Indoor Station Firmware V2.2.2_build221223

Release Note (2022-12-30)

Device Model	DS-KH6320-LE1(B), DS-KH6320-LE1(B)/White, DS-KH6320-TE1(B), DS-KH6320-WTE1(B), DS-KH6350-WTE1, DS-KH6350-TE1, DS-KH6351-TE1, DS-KH6351-WTE1
Firmware Version	V2.2.2_build221223
iVMS-4200	V3.8.3.1 or later

B. Link indoor station with main and sub door station

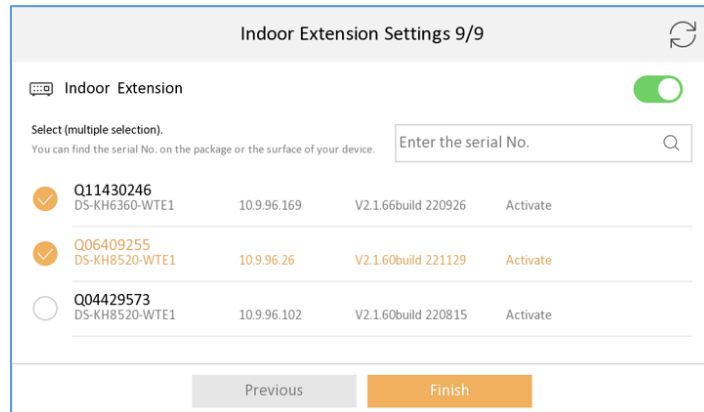
- the first selected will be the main door station by default, the second will be sub1, 3rd will be sub2, etc. You can also cancel and select the main door station manually.
- Maximum select 17 door stations at one time (1 main and 16 sub door stations)
- If the selected devices are not activated, indoor station will activate them with same activation and registration password, then set the IP address for them in same network segment automatically.
- If the door station is already activated with different password, it will prompt you to input door station password
- If the main and sub door station are activated with different activation password, the registration will be failed (sub door station can't call indoor station).

D. Pairing with main door station, sub door station and indoor extension

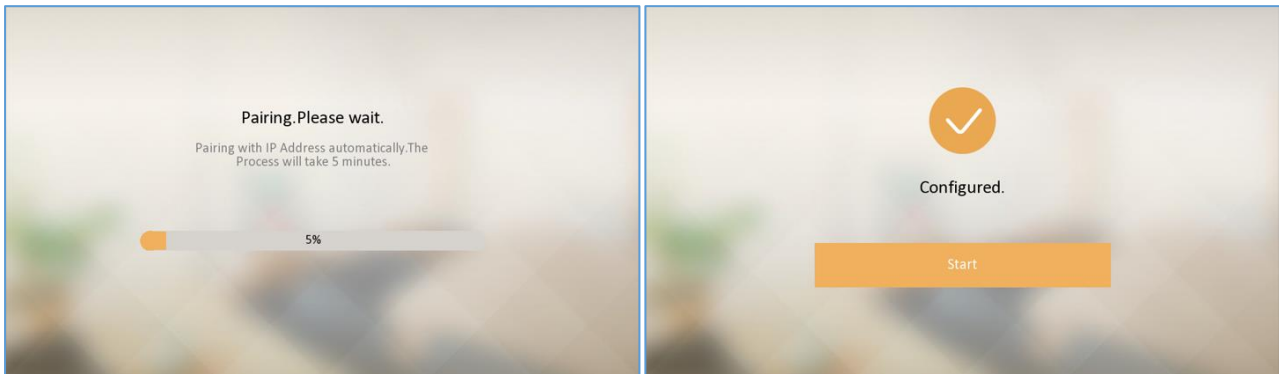
Note: The pairing time duration depends on the device quantity you selected in previous steps, it will take about up to 5 mins, please wait patiently until the process finish and show “Configured” as below.

2. Set the important parameters of door station from indoor station Menu-Advanced settings-Configuration-Device Management-Main Door Station (not from the wizard).

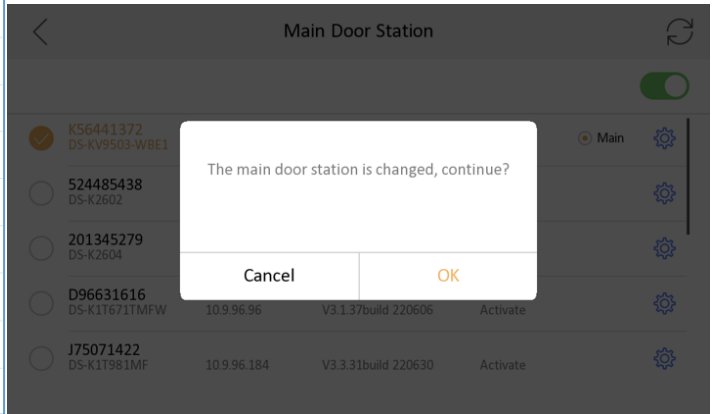
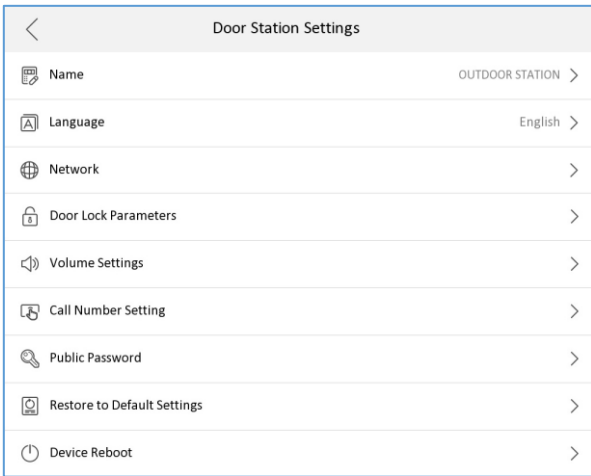
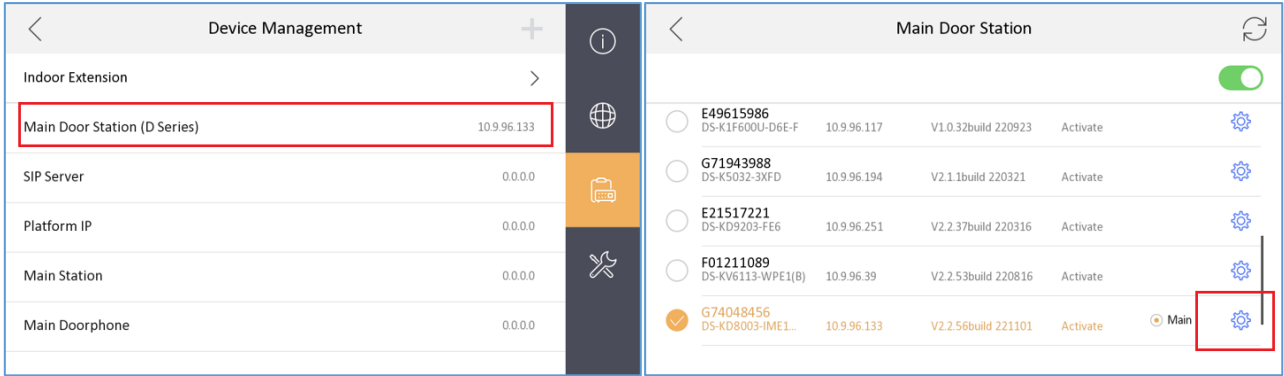
- A. You can change parameters of all door station (no matter it's linked or not) in the list by click the setting icon, see pic 2.
- B. You can also change linked main door station from this list by click device from the list, if you want to change linked sub door station, please go to Advanced settings-Configuration-System maintenance-Wizard, and link device again.
- C. After change the linked main door station, device will prompt “The main door station is changed, continue?”, see pic4 as below

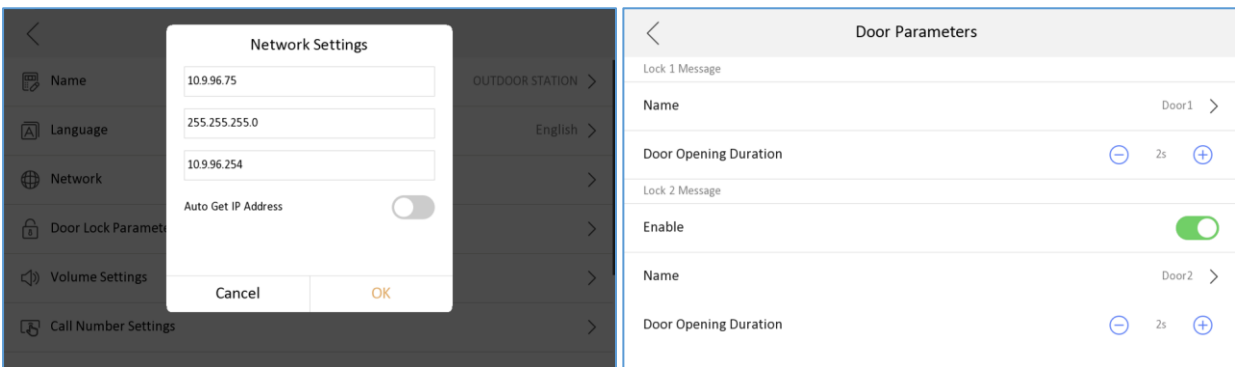
- A. Set door station name (will be displayed in live view page), set door station language.

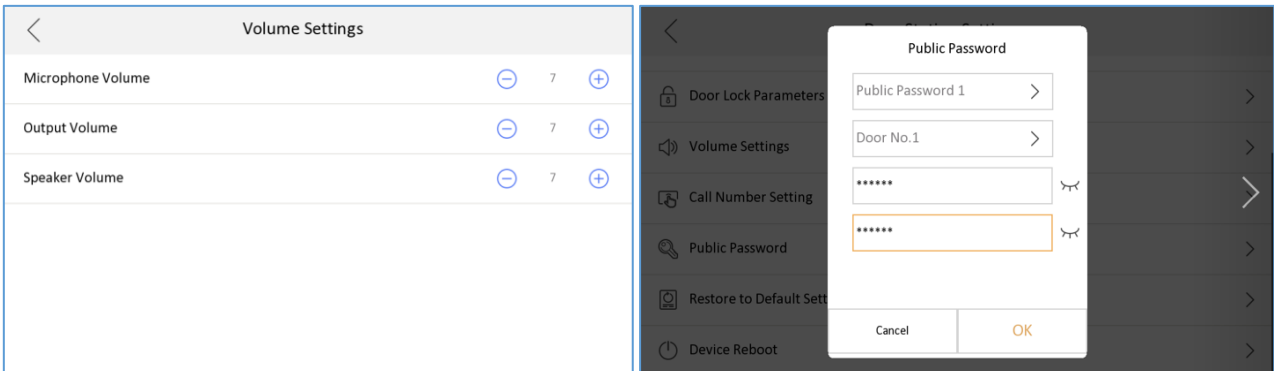
B. Set door station IP address, subnet mask, gateway, enable DHCP, lock name, door open duration, enable lock2, etc.

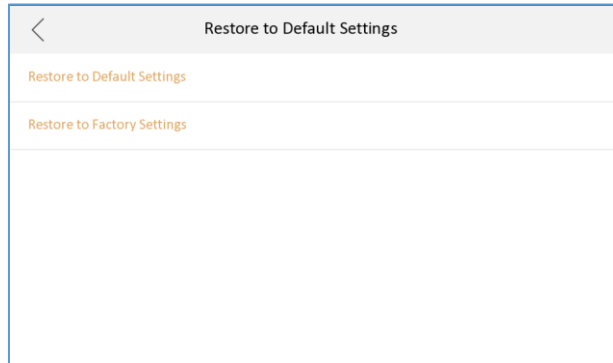
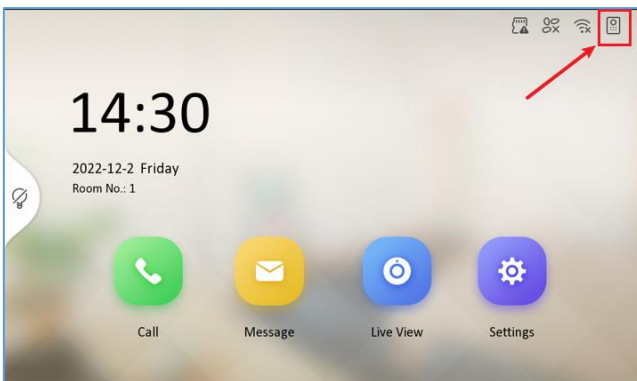
C. Door station volume setting, physical button call number, public password (lock1 or lock2)

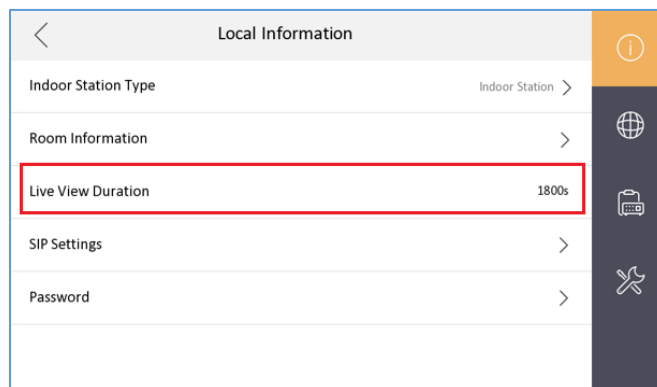
1. Optimized the icon of door station registration status in the main UI up right corner.

Note: If the door station call indoor station failed, you can click this icon  to register to door station manually, if register failed, it will indicate the reason for the failure.

Before	Now
Indoor station registers to door station success		
Indoor station registers to door station failed		
Indoor station registers to door station and KM9503 success

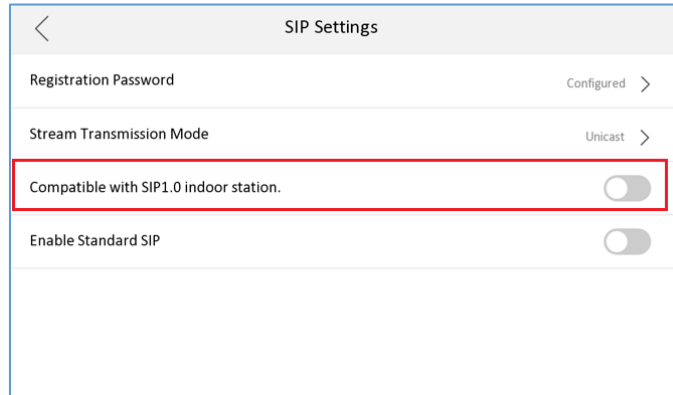
3. Support switching between protocol 1.0 and 2.0, by default it's protocol 2.0
After enable, the indoor station is compatible with protocol 1.0 indoor extension and not

compatible with protocol 2.0 indoor extension.

Note: After enable, all indoor extension of this indoor station must be protocol 1.0 firmware, don't mix protocol 1.0 and 2.0 indoor extension under same indoor station, or it will result to calling failed.

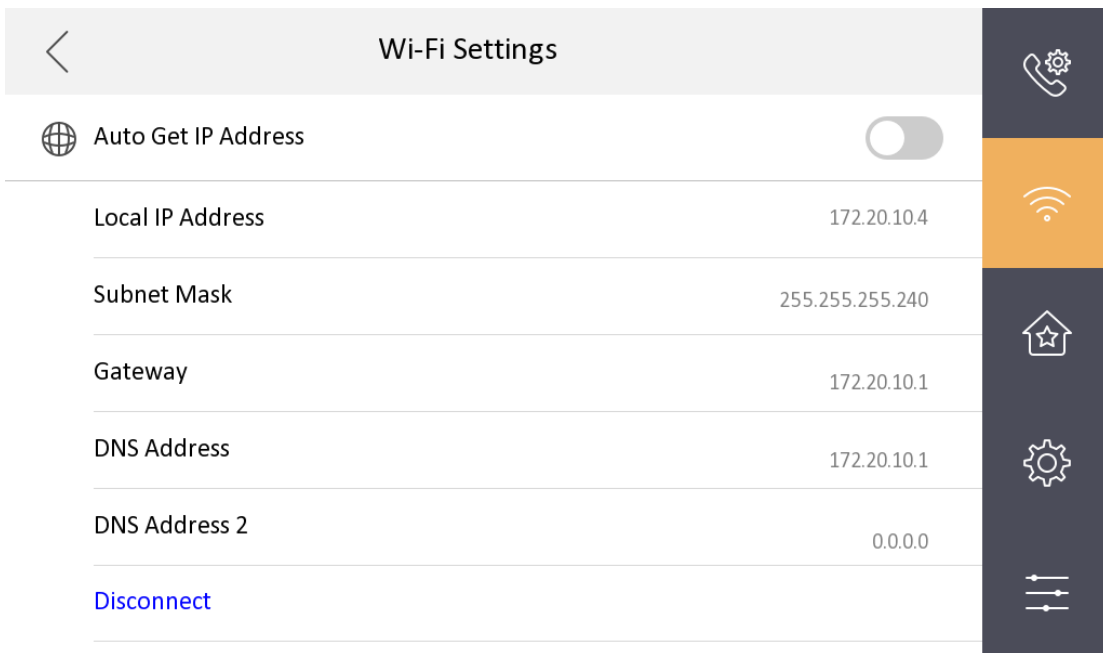
1. Support configure the Static IP of Wi-Fi (enable device configure DHCP, IP address, Subnet mask, gateway, DNS1, DNS2).

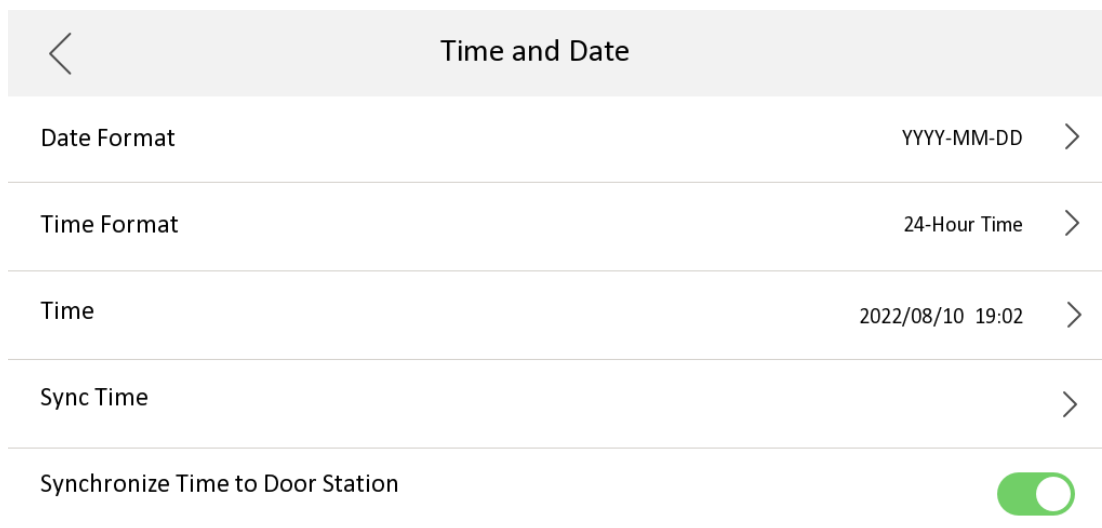
2. Indoor station supports configuring time and time zone information for the door station.

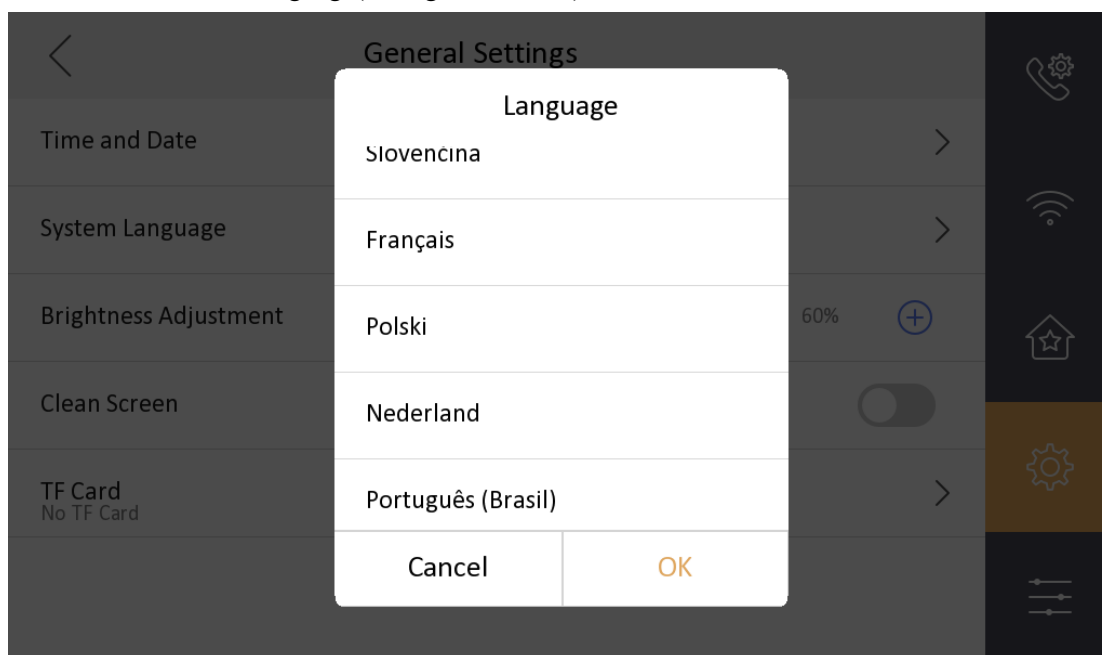
4. Two new Standard language(Portuguese,Slovak) have been added.

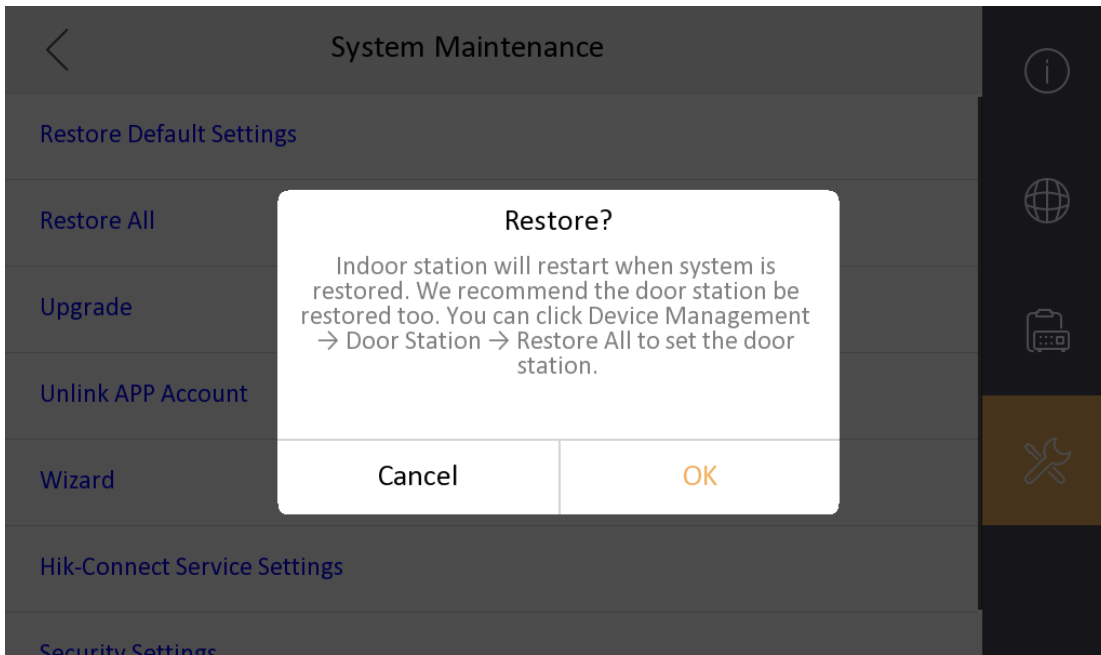
1. Fix the indoor station maintenance interface. When click restore or restore all, a prompt information will pop.

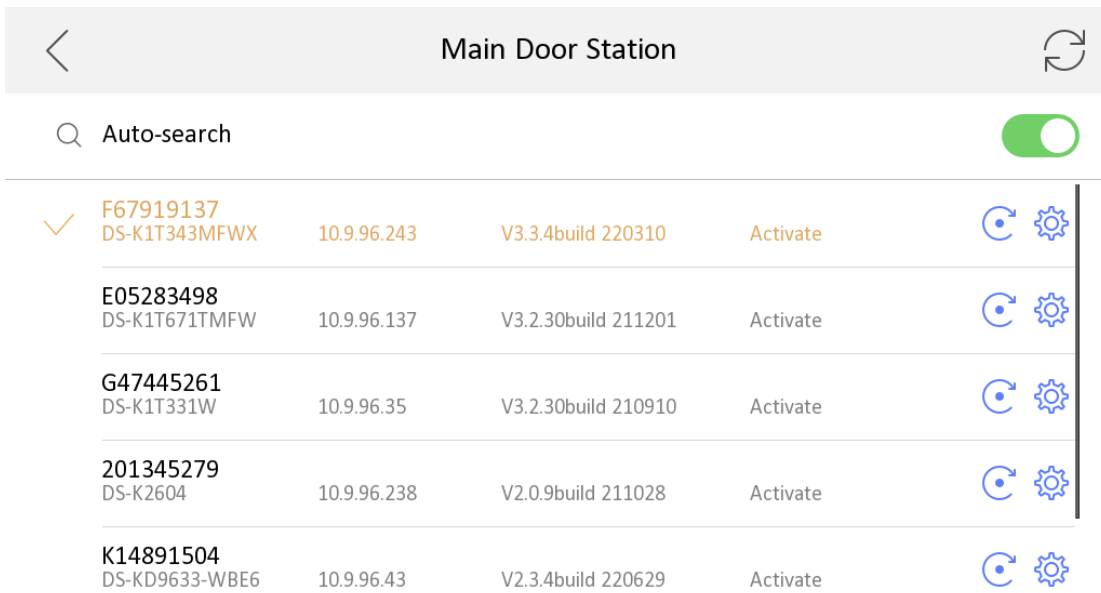
2. The indoor station wizard-related devices added the effect of selecting the door station.

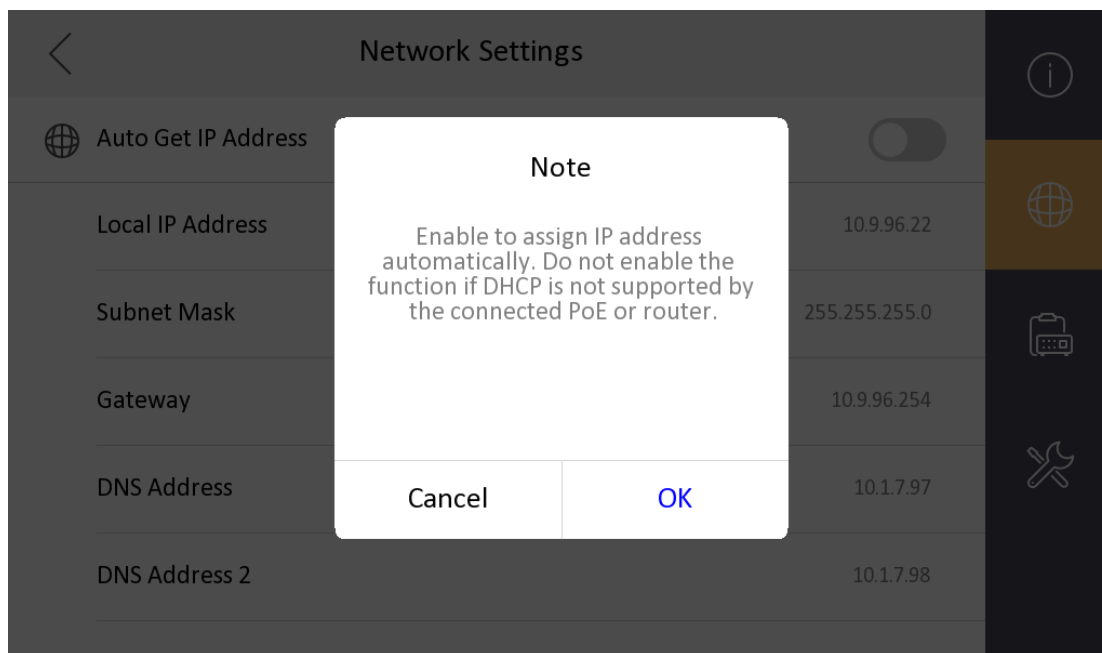
3. Add a prompt information when assign network IP address automatically.

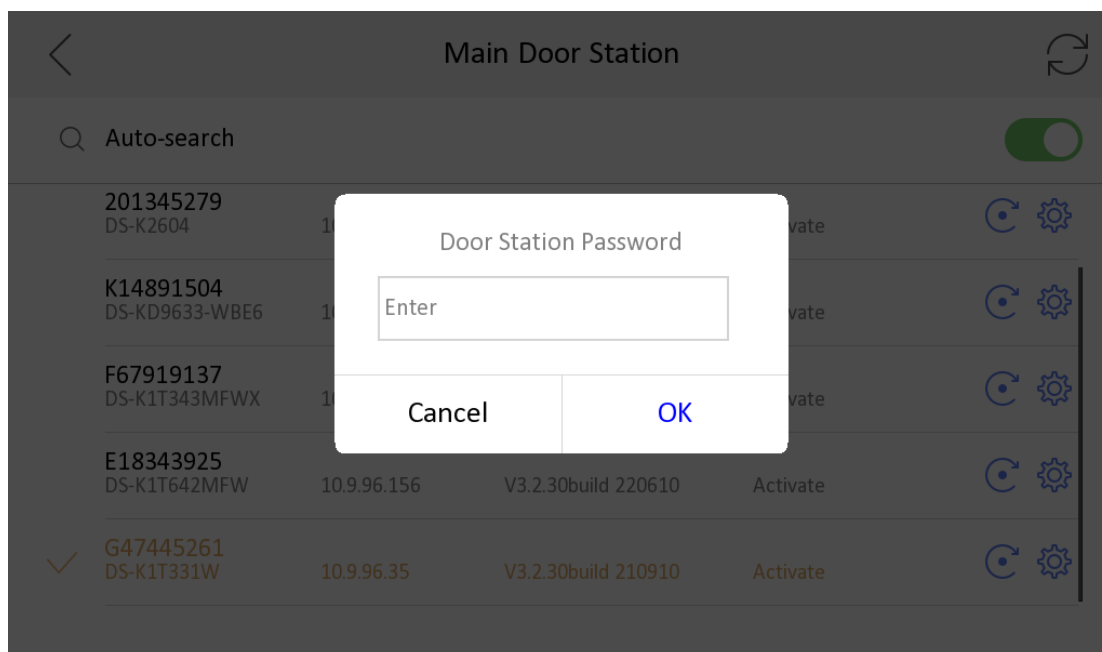
4. In configure wizard to related door station, when the door station password is different from the indoor station, prompt information will pop.

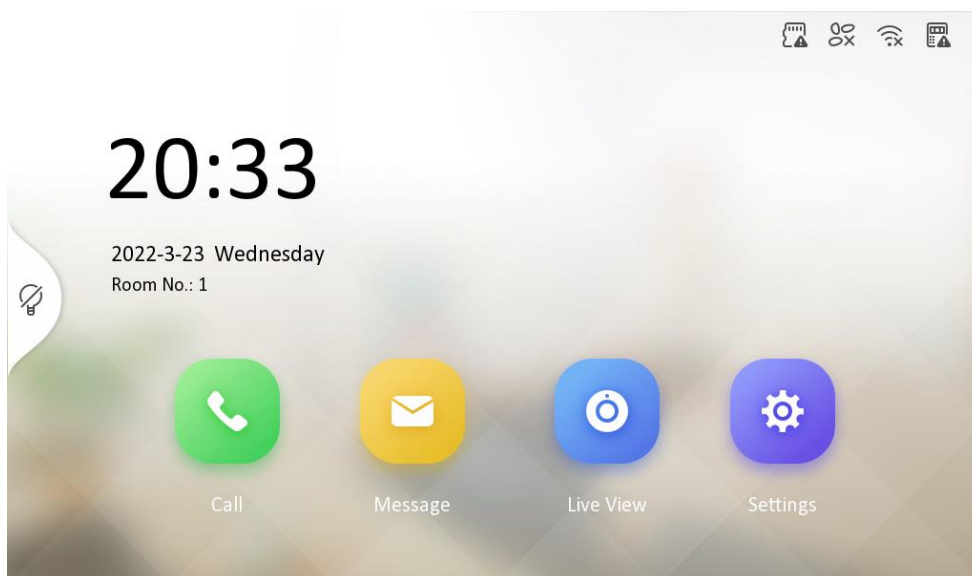
1. New version of the device is based on the last version and develop new appearances.
